DEVELOPMENT REVIEW BOARD
SUPPLEMENTAL SUBMITTAL

SUBMITTAL DESCRIPTION: Plan Updates and response to comments

Project Name: Mesa View United Methodist Church/SARANAM

DRB Project Number: 003461
Mesa View United Methodist Church Inc.

ENGINEER'S SEAL RONALD R. BOHANNAN NEW MEXICO 7868 PROFESSIONAL ENGINEER 7/28/2020 RONALD R. BOHANNAN P.E. #7868	SARANAM AT 4701 MONTANO RD NW SITE PLAN	DRAWN BY BF DATE 7/28/2020 2019080_SPE SHEET # C1 JOB # 2019080
---	---	--

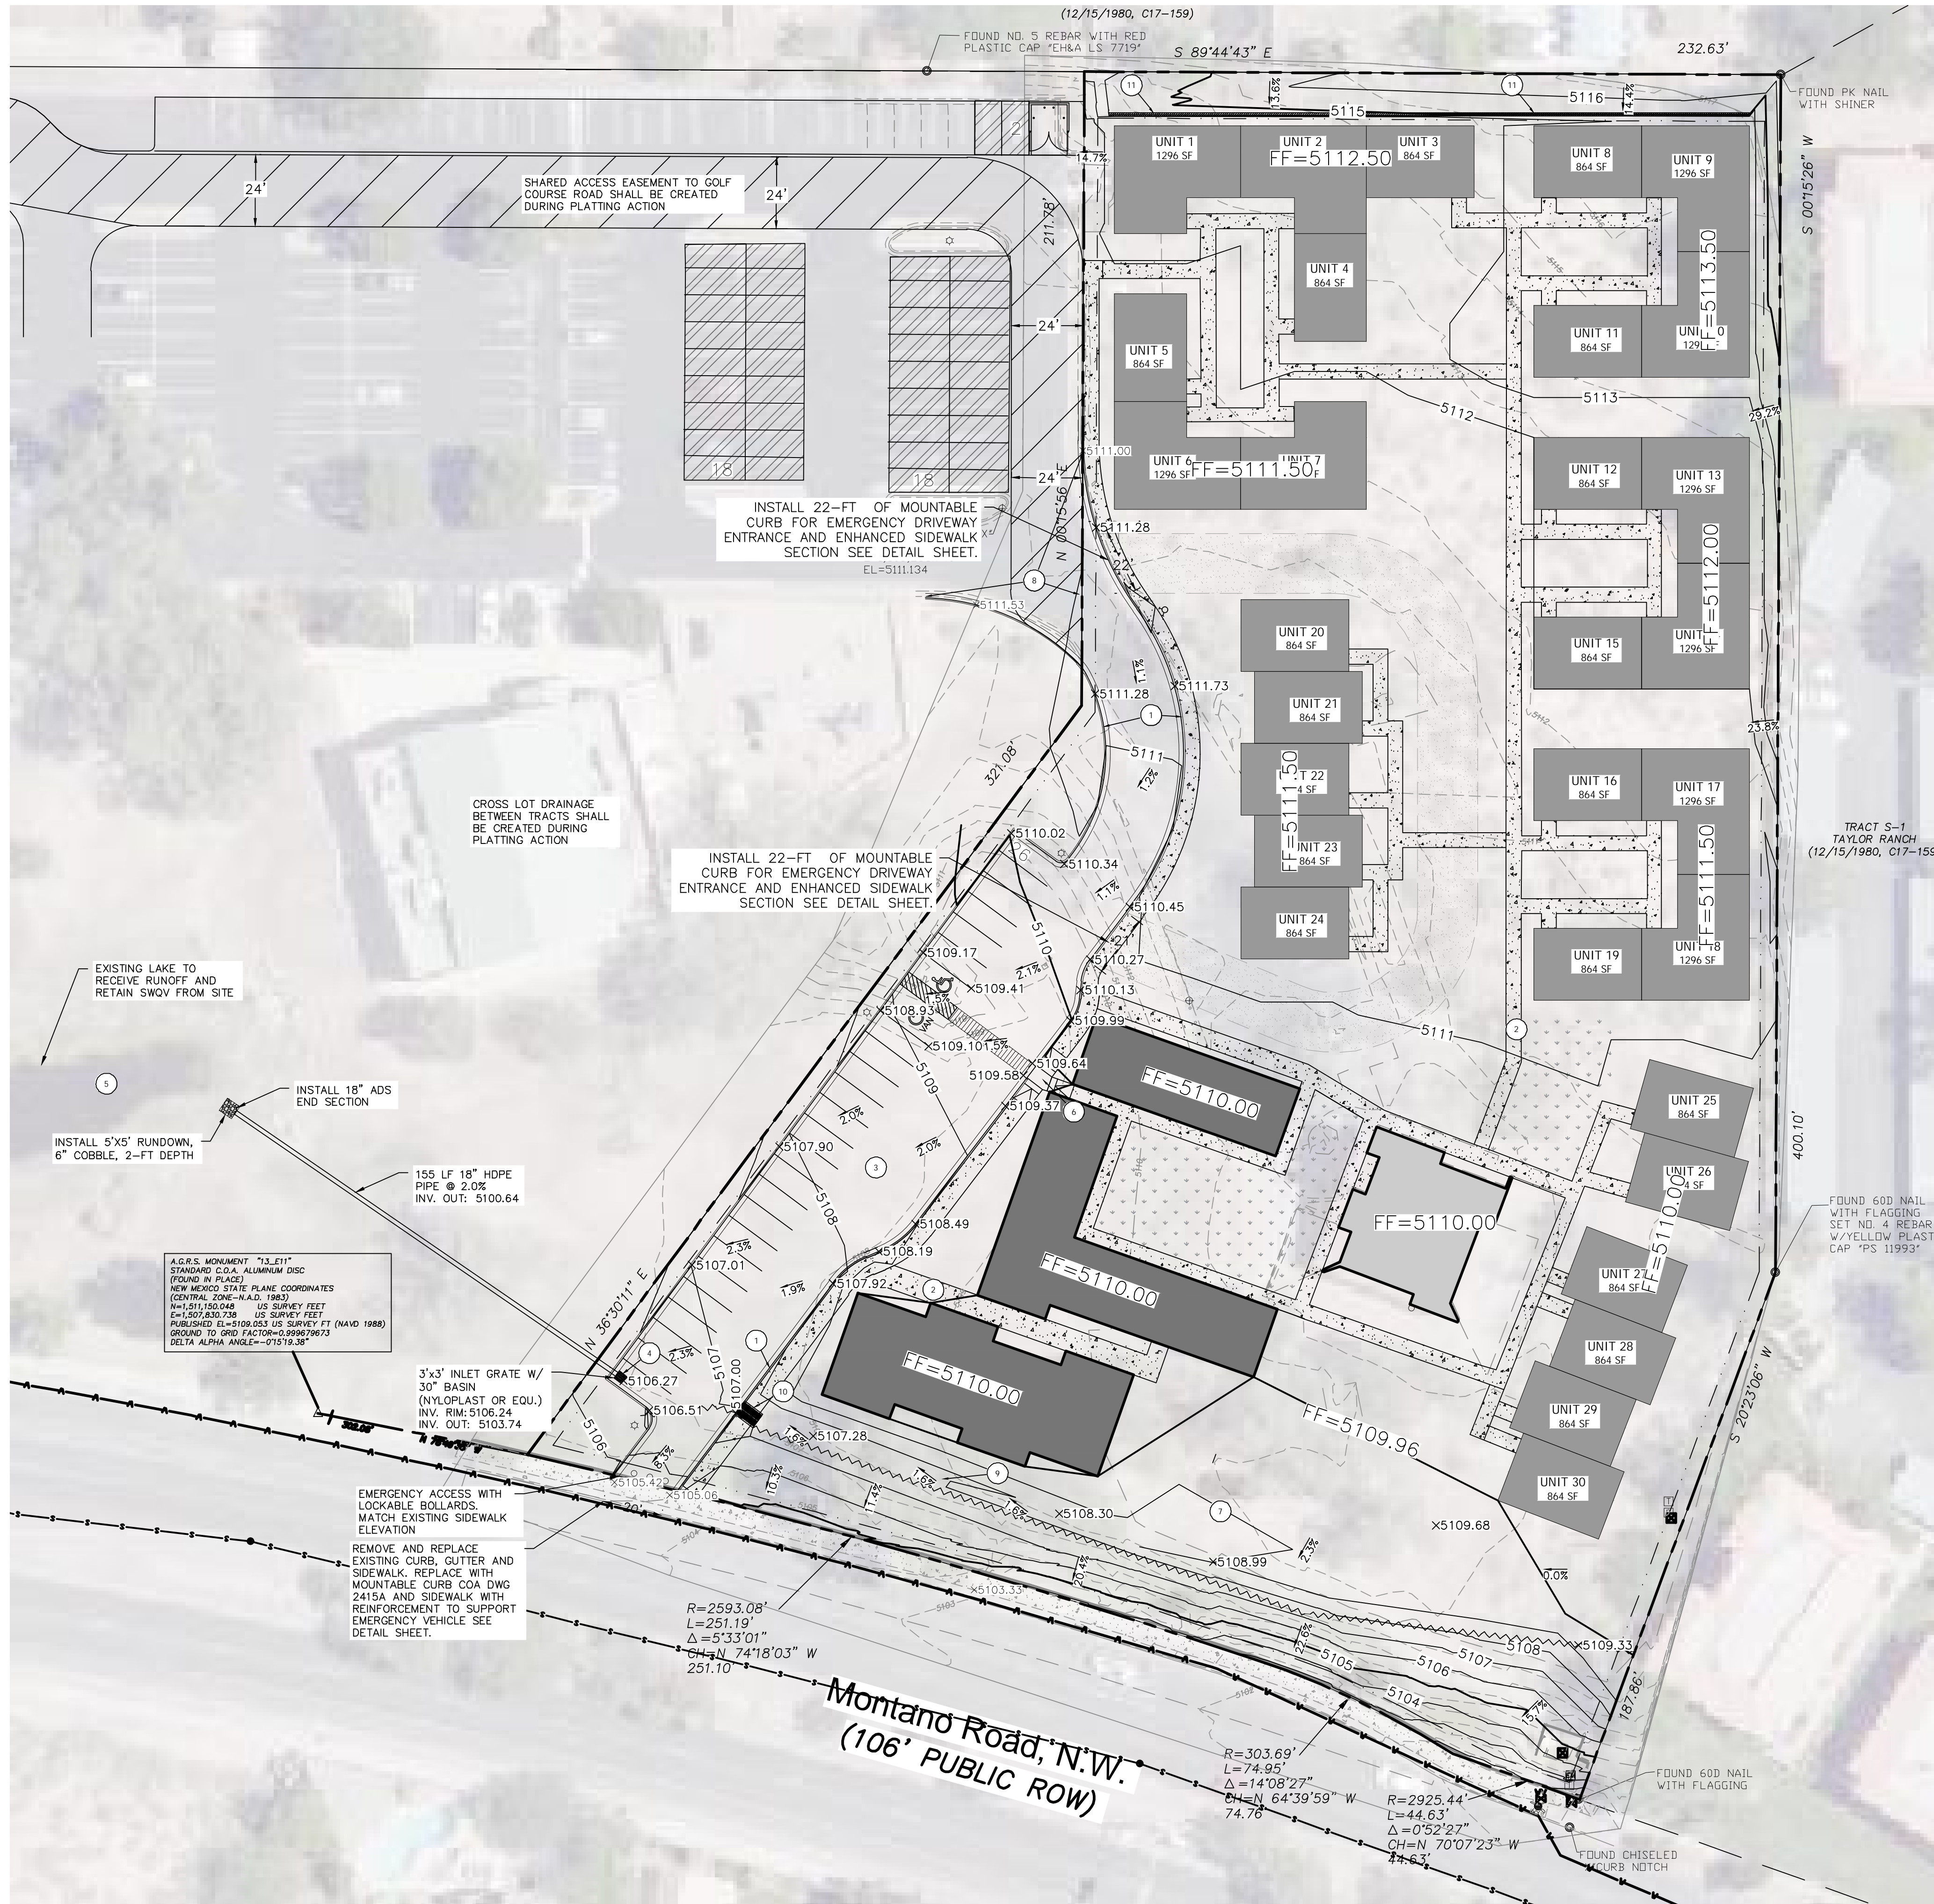
2. The road that Montano Road intersects with is Taylor Ranch Road. Provide correct label on the site plan.

Response: Label on site plan updated.

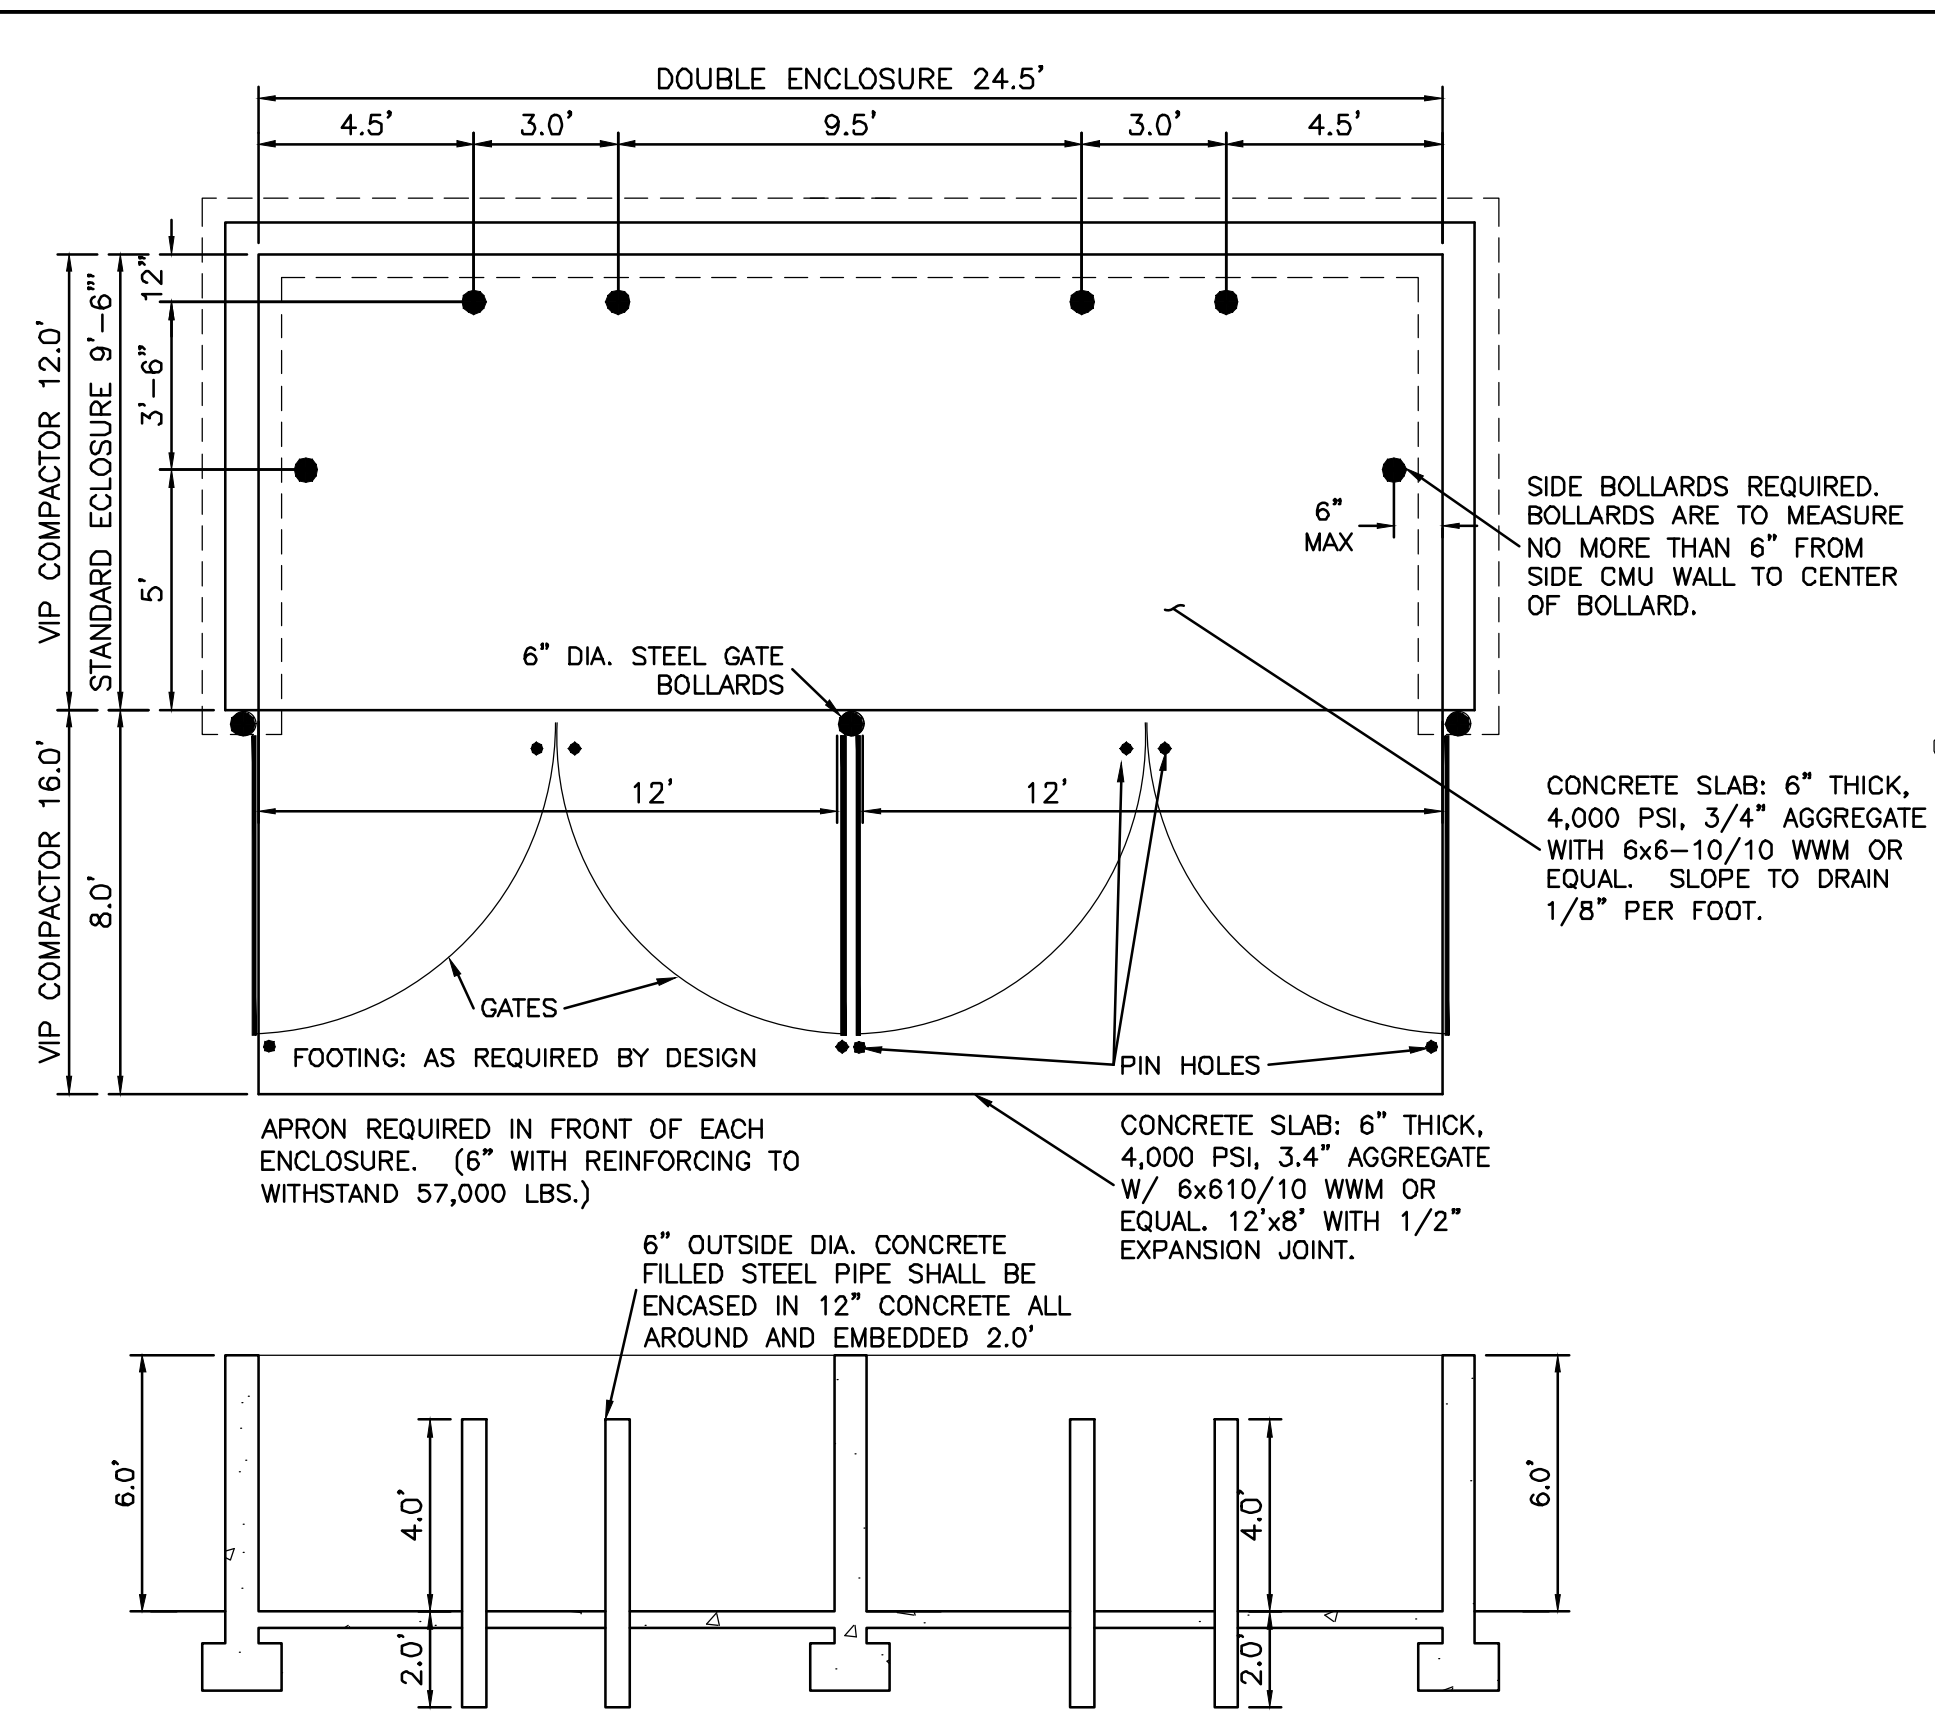
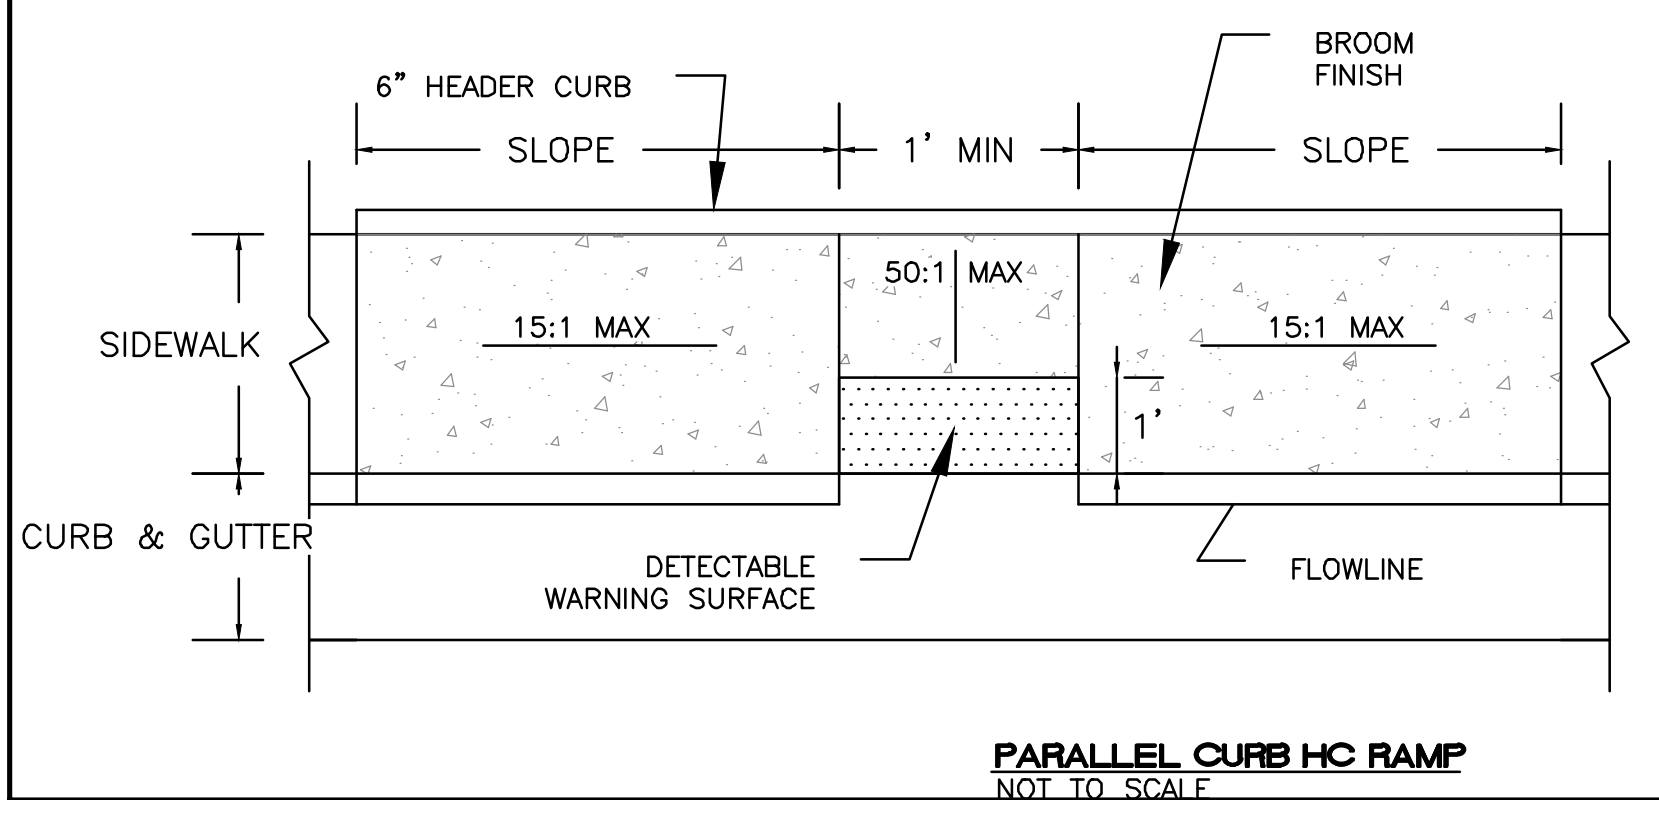
3. What is the foundation for the bollards?

Response: Concrete, added callout detail to sheet C5.
